Work Order ID 110791

Item Name: Replacement Skidtube, High Gear Run-On Landing (Fits LH or RH)

DRAWING NO. D3804	TITLE SKIDTUBE ASSEMBLIES, 206A/B	REV. A	DART AEROSPACE LTD ENGINEERING ORDER		D.E.O. NO. D3804-A-1	SHEET NO. SHEET 1 OF 1	SCALE NTS
DRAWN <i>CP</i>	CHECKED <i>A.P.</i>	MFG. APPR. <i>[Signature]</i>	APPROVED <i>[Signature]</i>	DE APPR. <i>[Signature]</i>			
DATE 12.10.12	DATE 12.10.22	DATE 12.10.22	DATE 12.10.22	DATE 12.10.22

CHANGE C'BORED WELDED CROSSBOLT SPACERS TO SWAGED SPACERS

WAS:

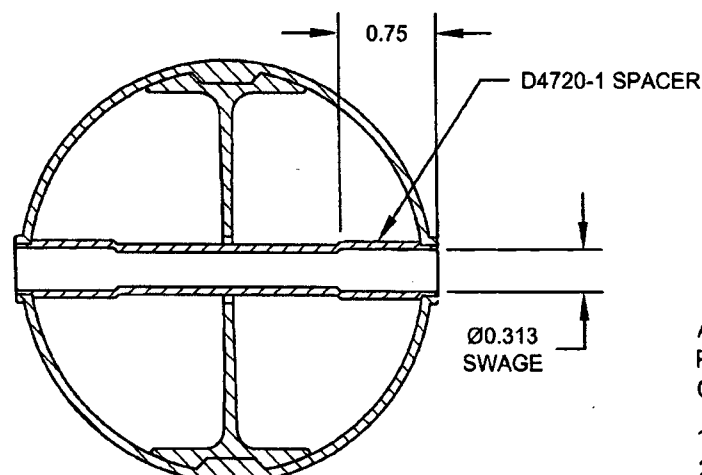
19	20	D2649	CROSS BOLT SPACER
----	----	-------	-------------------

SECTION H-H

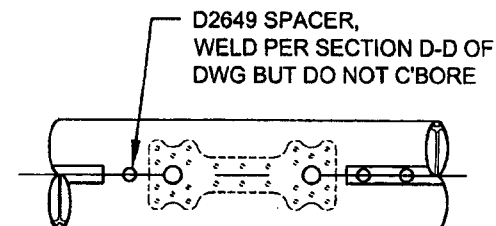
ADD SECTION H-H BELOW, WHICH IS THE SAME SECTION VIEW AS SECTION D-D OF DWG.
C'BORED HOLES ARE **NOW SWAGED** PER SECTION H-H BELOW. FOR THE Ø0.375 HOLE THAT IS NOT C'BORED, WELD PER SECTION D-D OF DWG (SEE AMENDED DETAIL B FOR REFERENCE).

FOR Ø0.375 HOLES ONLY

FOR HOLES THAT ARE CURRENTLY C'BORED ONLY
NOT TO SCALE
